6X4 eAxle Breather Hose Relocation to Reduce Water Intrusion Risk

TSB-35-043-FTL

Engine or Vehicle Affected:

► eCascadia

Fig. 1, Breather Line Routing and Cable Tie Locations

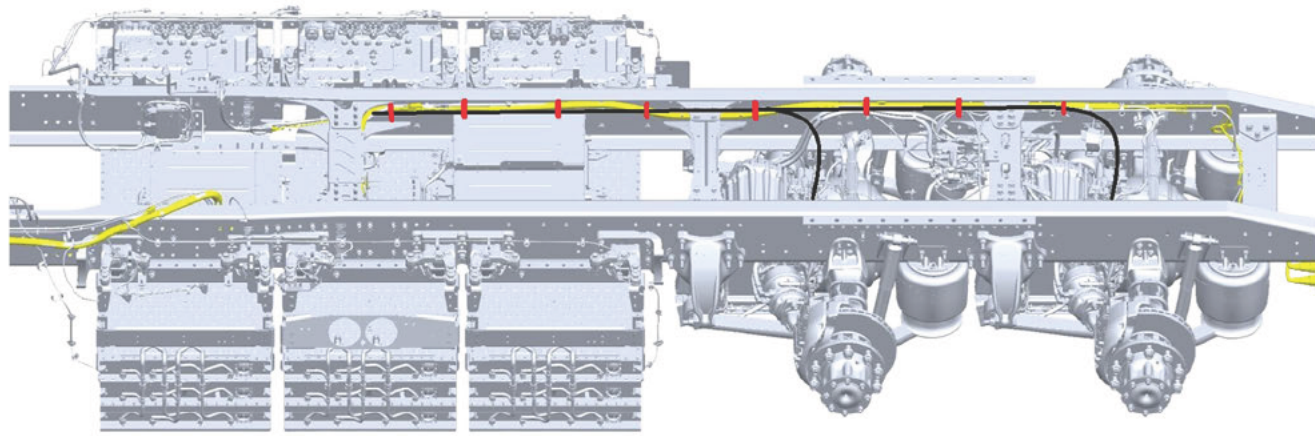
eCascadia 6x4 vehicles built from January 4, 2023 through February 23, 2026, have an axle breather hose that terminates on the side of the eCarrier in an area exposed to high road spray. During operation in wet conditions, water may enter the axle housing through the breather system and contaminate the axle lubricant. Contaminated lubricant may appear milky during routine maintenance inspections, such as axle oil level checks or oil changes. If this condition is found, update the axle housing vent line routing using the procedure in this bulletin.

- ☐ Park the vehicle on a level surface, shut down the vehicle, and apply the parking brake. Chock the tires.
- ☐ Remove the four between-rail deck plates.
- ☐ Cut all cable ties securing the old breather lines. Disconnect the breather air lines from the eCarrier and remove them from the vehicle.
- ☐ Route the new breather lines (one per axle) from the front side of the crossmember 561, located between the inverters, to the eAxle breather line fittings. See Fig. [1](#).

Fig. 2, eAxle Breather Line Connection Point

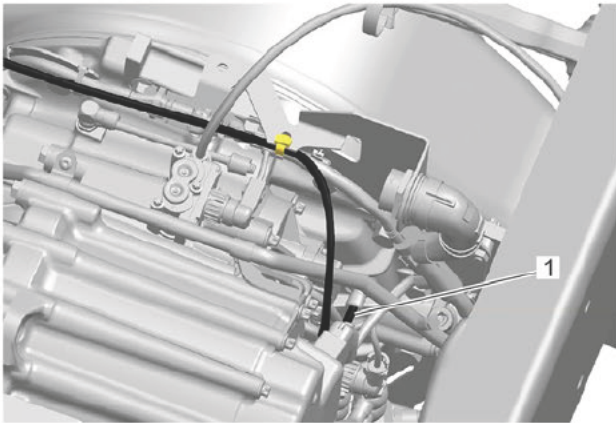
5. ☐ Secure the new breather lines using the specified cable ties at the locations shown in Fig. 2.

Fig. 3, Trimming Breather Lines to Fit

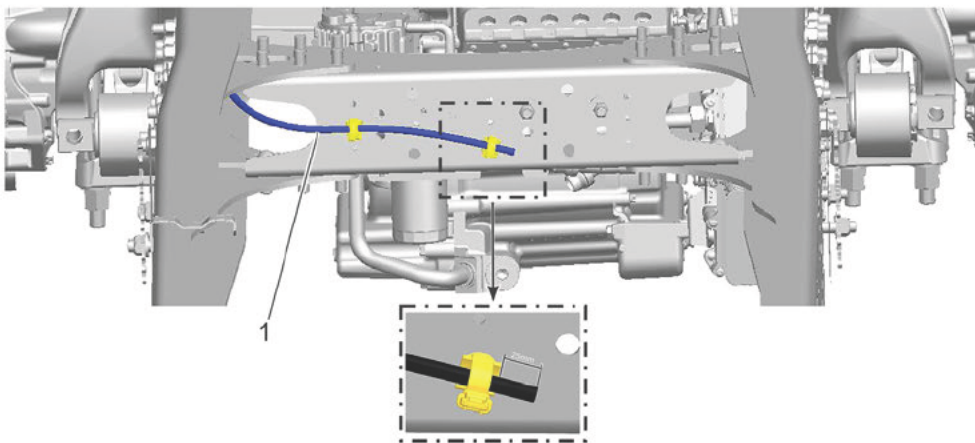
6. Trim the breather hose to fit, leaving approximately 1 inch (25 mm) of hose extending beyond the fir tree clip as shown in Fig. 3.
